Donnybrook JV Pty Ltd

Expert Buffer Assessment

960 Donnybrook Road, Donnybrook

October 2020

Figure 1 Woody Hill – Extent of Operational Noise Buffers

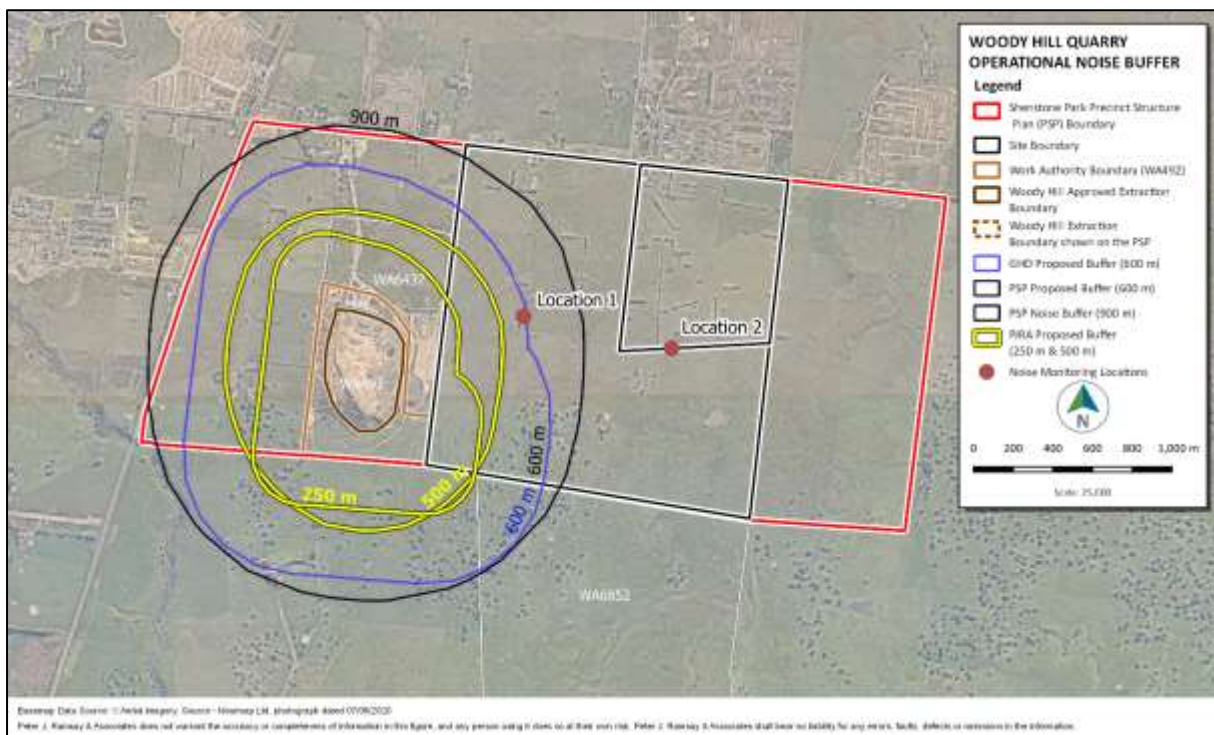
Plan 15 of the original PSP suggests an operational noise buffer of 900 m from the extraction area boundary; this buffer was not changed in Plan 15 of the revised PSP dated October 2020.

I note that the inputs to the noise modelling provided in the Impact Assessment Report (GHD 2017) and Addendum Report (GHD 2019) provide for elevated noise sources with no noise controls in place. The existing quarry operations from the Woody Hill Quarry could have been monitored rather than modelled. I note that some background noise monitoring was performed for preparation of the Impact Assessment Report (GHD 2017). In this report, GHD includes the following note regarding noise monitoring, "*Note that there was no Woody Hill Quarry operational noise audible at the time of GHD site visit at both monitoring locations*". This attended monitoring was performed on the 25th of August 2017.

I also note that Figure 22 of the Impact Assessment Report (GHD 2017) suggests the existing quarry operations would have approximately 15 dB(A) difference in predicted noise impact at the monitoring Location 1 and 2. Whereas, the unattended monitoring indicated a measured difference of 2 to 3 dB(A) in daytime ambient noise between the locations, according to a comparison of Tables 9 and 10 of that report.

I consider the use of the 500 m separation from the area where blasting may occur (i.e. the Approved Extraction Area within WA492) and the 250 m separation from other areas of potential quarry operation (i.e. the WA492 boundary) to be appropriate to provide protection against noise impacts. This is consistent with the buffers applied to similar quarries as discussed in Section 3.1 in this report.

Figure 2 Woody Hill – Extent of Blast Generated Vibration Buffers

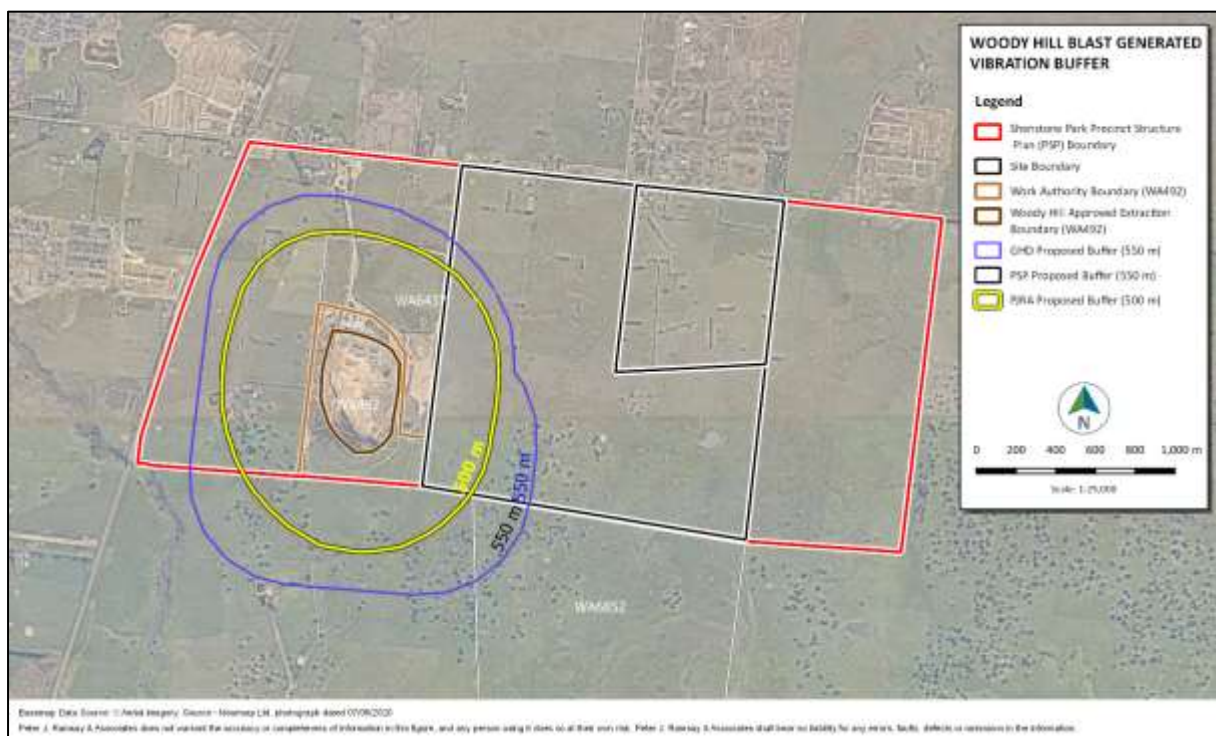
The basis for the separation distance proposed in the GHD Impact Assessment (GHD, 2017) is a vibration assessment from a British Standard. However, GHD did not discuss whether this standard is applicable for this particular setting with regards to the geology and blasting methods. I note that the standard allows for different separation distances based on different blasting methodologies, however the operator of the quarry was not consulted regarding the planned blasting practice.

I consider the use of the 500 m buffer from an area where blasting may occur, as provided for control of dust impact in EPA Publication 1518, to be appropriate to provide protection against vibration impacts. This is consistent with the buffers applied to similar quarries as discussed in Section 3.1 of this report.

368 **Figure 3** **Woody Hill – Extent of Blast Generated Dust Buffers**

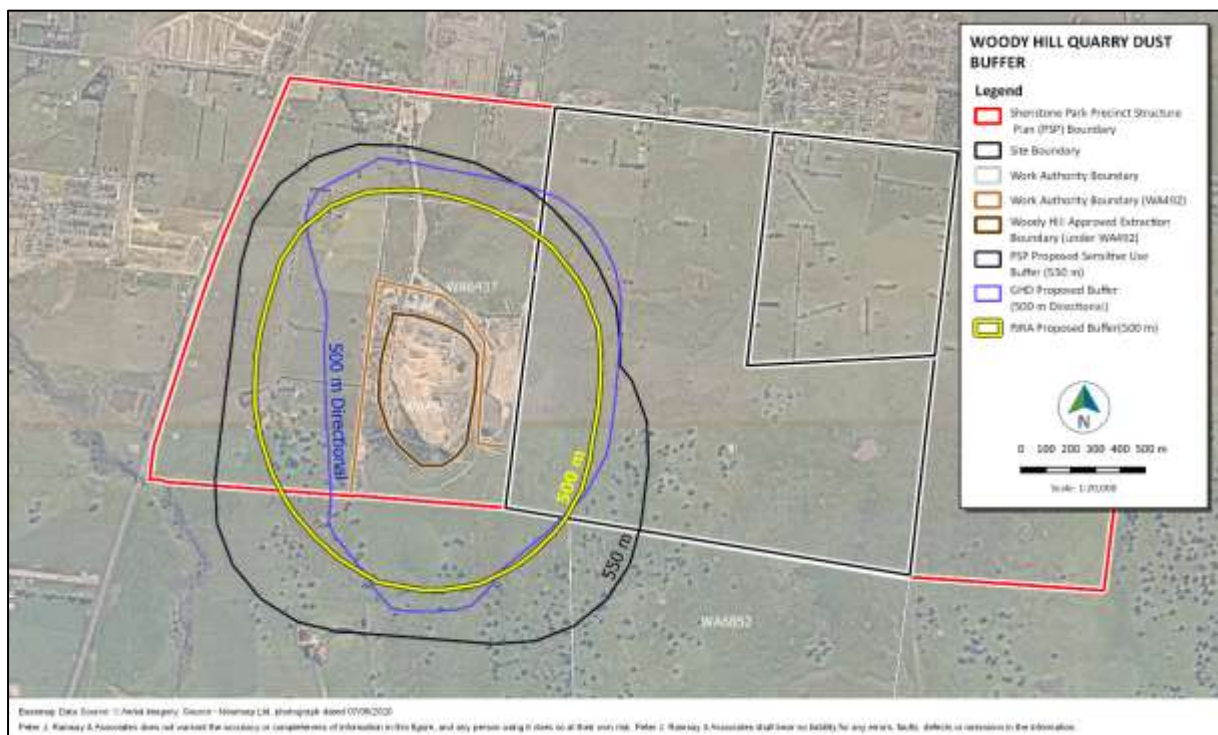
355 The PSP provides a 550 m buffer from the outer extent of the area marked “Woody Hill possible
356 extraction expansion” on Plan 15 of the PSPs to protect against dust impacts from the quarry operations.
357 I assume that this is intended to provide protection against blasting activities and other quarry activities
358 at the Woody Hill Quarry.

359 GHD (2019) recommends using a 500 m directional buffer to protect against dust impacts from quarry
360 operations. The buffer is proposed to extend more than 500 m east of the Work Authority Boundary.

I consider the use of the 500 m buffer from an area where blasting may occur, as outlined in EPA Publication 1518, to be appropriate to provide protection against dust for more sensitive uses. There is no justification for the use of a directional buffer, therefore this should be a linear separation distance from the outer extent of the Approved Extraction Area on WA492. This is recommended in EPA Publication 1518 and is consistent with the buffers applied to similar quarries as discussed in Section 3.1 of this report.

Figure 4 Woody Hill – Blast Generated Fly-Rock Buffers

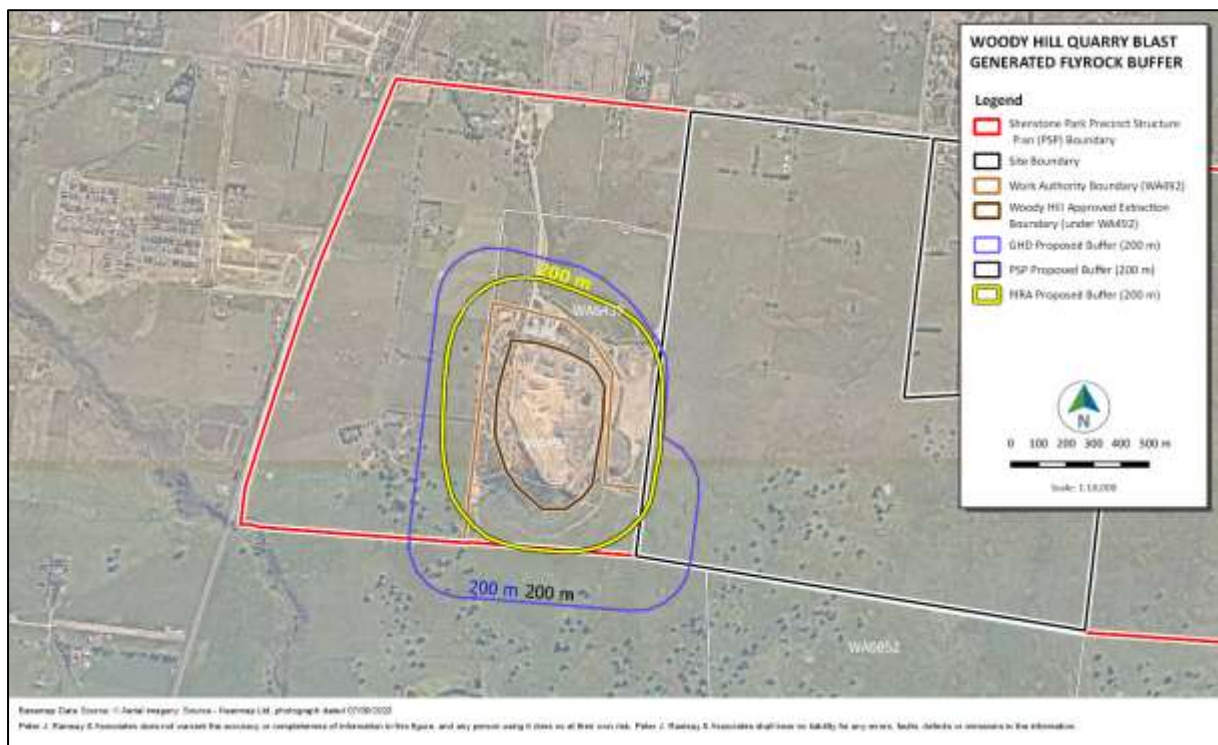
I consider the use of a 200 m buffer from the proposed extraction area to be appropriate to provide protection against blast generated fly-rock impacts. This is consistent with the buffers provided to similar quarries as discussed in **Section 3.1** of this report.

Figure 5 Woody Hill Expansion – Extent of Operational Noise Buffers

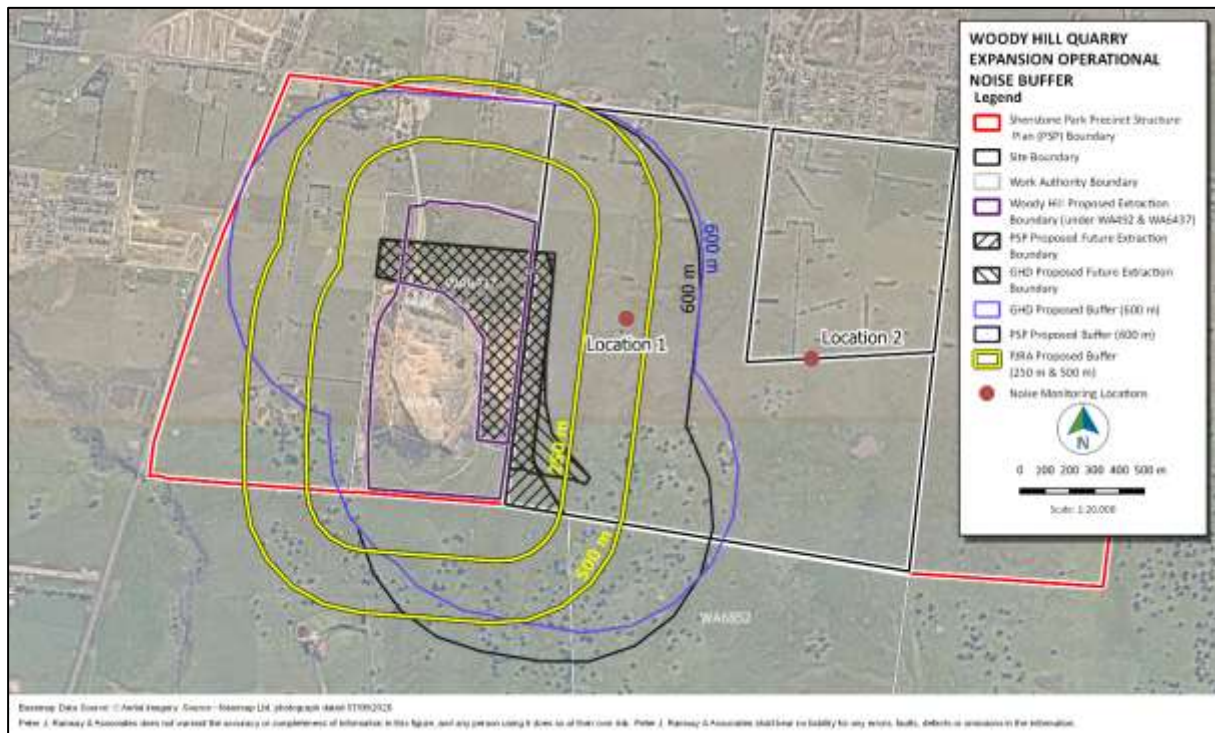
As discussed in **Section 5.2.1**, I consider that the methodology for assessing the extent of the separation distance is flawed. As also discussed in **Section 5.2.1**, I consider the adoption of a 250 m buffer from the outer boundaries of the land subject to WA492 and WA006437 appropriate to provide protection against noise impacts.

Figure 8 Woody Hill Expansion – Extent of Blast Generated Fly-Rock Buffers

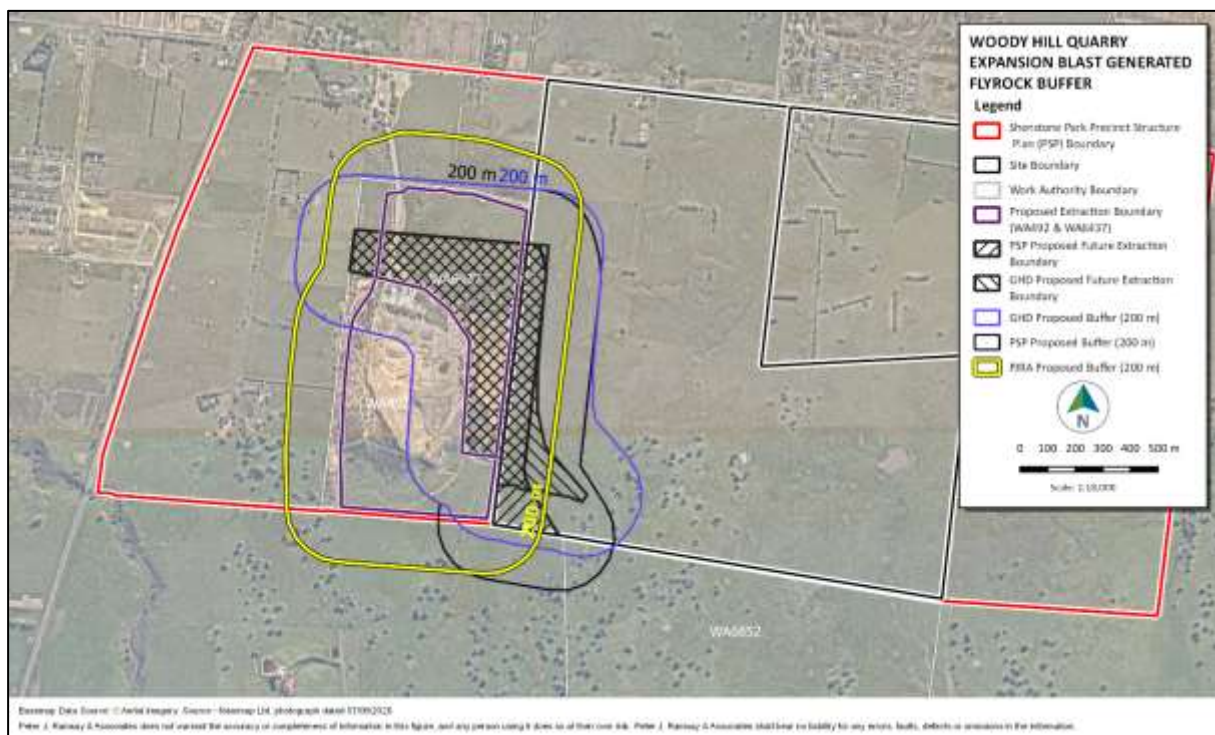
GHD (2017) recommends a 200 m separation distance for protection against blast generated fly-rock. This was adopted in Plan 15 of the original PSP dated September 2019 and retained in Plan 15 of the revised PSP dated October 2020.

I consider the adoption of a 200 m buffer from the proposed extraction boundary within WA492 and WA006437 to be appropriate to provide protection against blast generated fly-rock impacts.

Figure 10 Phillips Quarry – Extent of Blast Generated Vibration Buffers

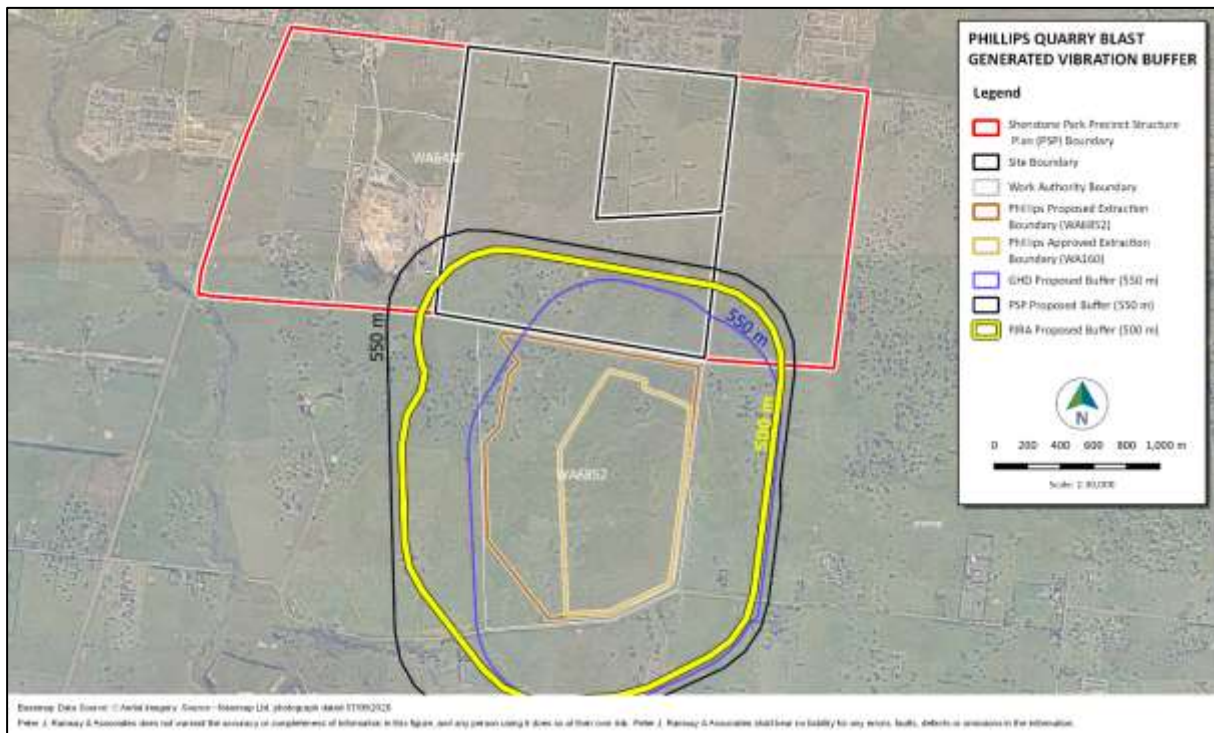
For the reasons discussed in section 5.2.4 of this report, I consider the use of a 500 m buffer from the approved extraction boundary to be appropriate to provide protection against blast generated vibration impacts.

500 **Figure 13 Summary of Recommended Separation Distances**

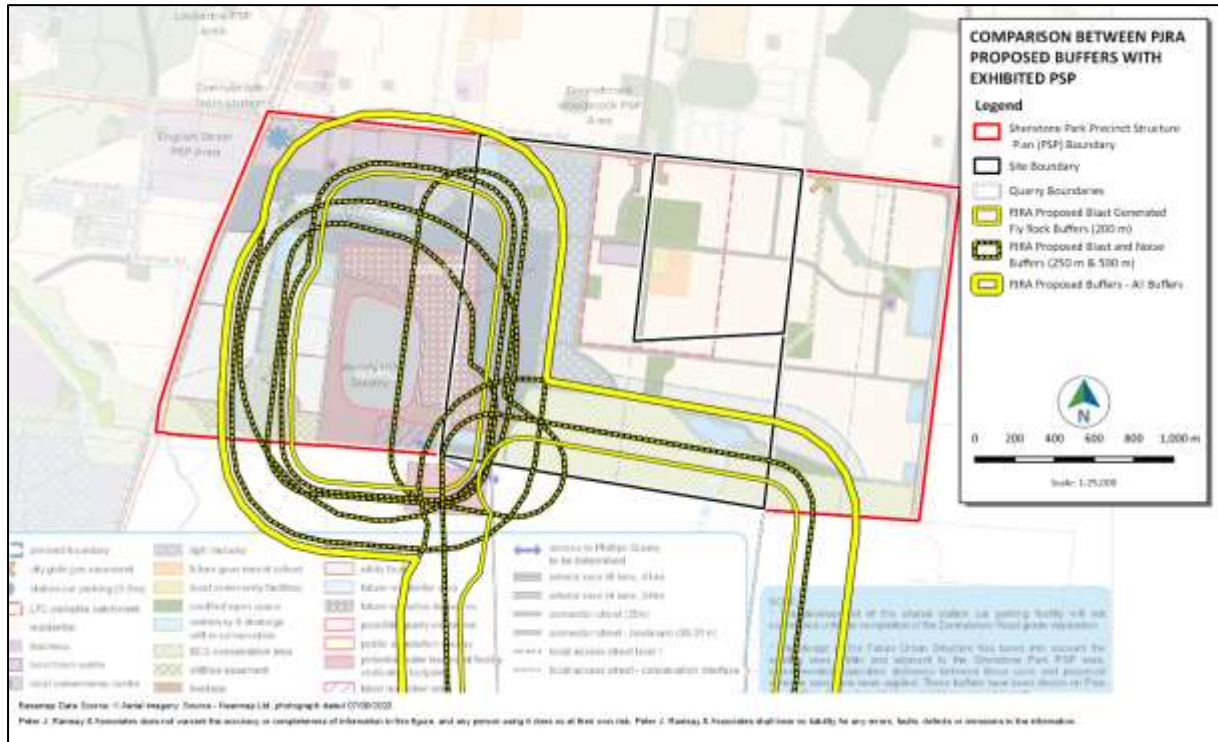
In accordance with EPA Publication 1518 separation distances should be measured from the relevant activity area. In the case of impacts associated with blasting and excavation, where reliable information is available regarding the areal extent of such works, then the separation distances should be measured from this extent.

The findings are not in accordance with the recommended separation distances between hard rock quarries using blasting techniques in similar geology, that have been applied in other recent situations where a separation distance has been put in place.

The extent of these separation distances is shown on **Figure 13** below.

503 **Figure 14 Summary of Recommended Separation Distances on Exhibited PSP**

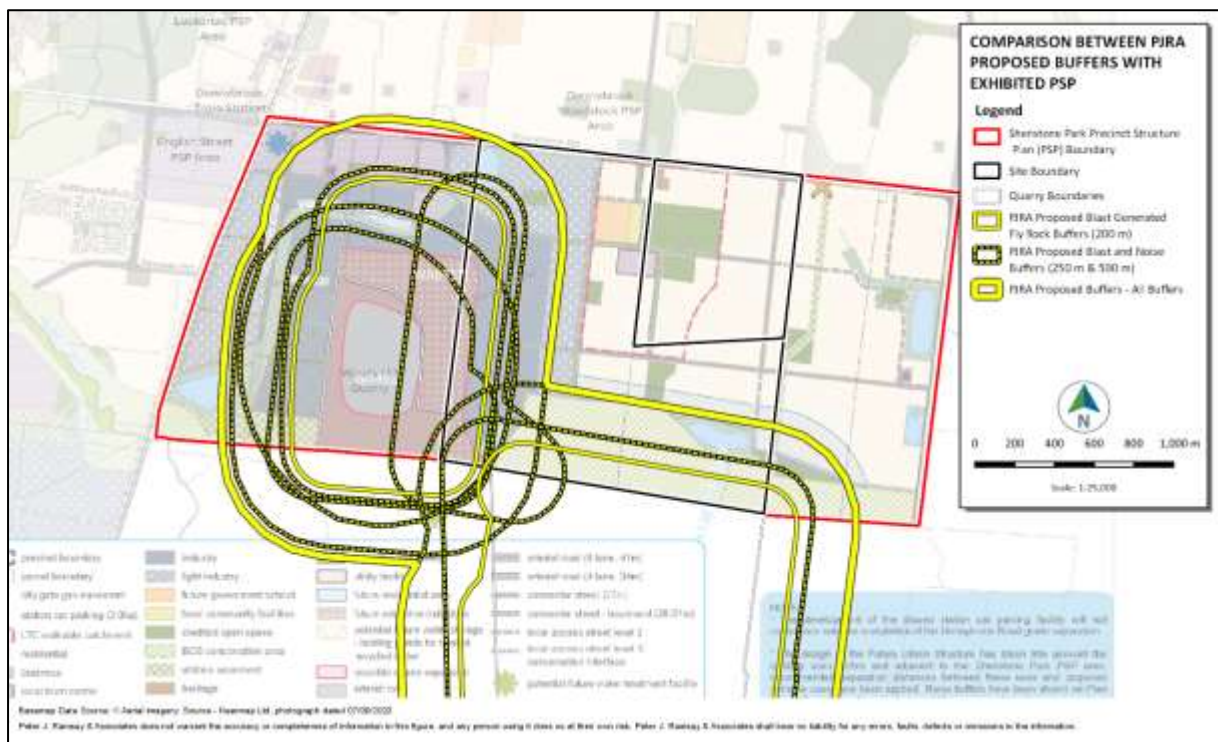
501 The buffers do not align with the interface land uses proposed in the initial PSP, shown in **Figure 14**; or
 502 to the land uses proposed in the revised PSP which are shown in **Figure 15**.

507 **Figure 16 Summary of Recommended Separation Distances against DJV Proposed Land Use**

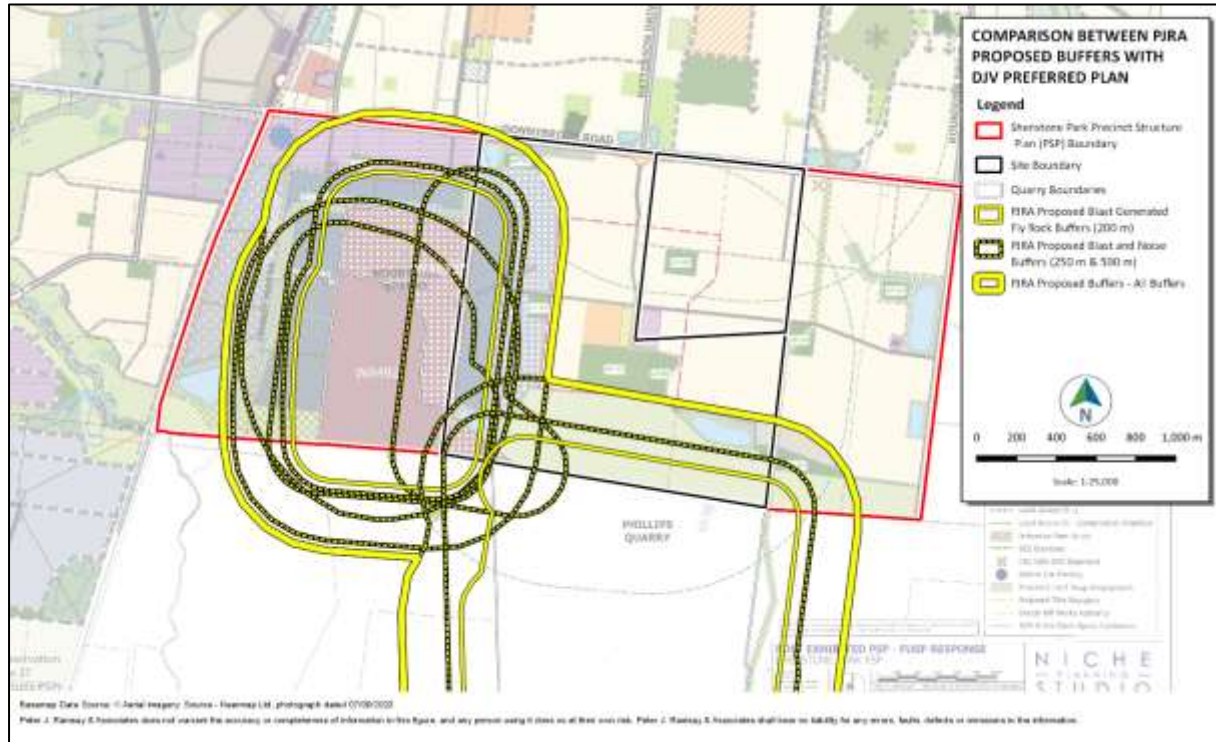
505 The interface land uses proposed in the FUSP put forward by the Donnybrook Joint Venture align with
 506 the separation distances and interface land uses I recommend. This is shown in **Figure 16**.

508 Therefore, the land uses proposed by DJV in the figure, Post Exhibited PSP – FUSP Response, 26
 509 October 2020 are compatible with the planned expansion of the Woody Hill Quarry under WA492 and
 510 WA006437 and with the proposed development of the Phillips Quarry under WA006852.

511 In addition, the PSP should be amended to clearly show the extent of the proposed expansion of the
 512 Woody Hill Quarry to the north as proposed under WA006437.
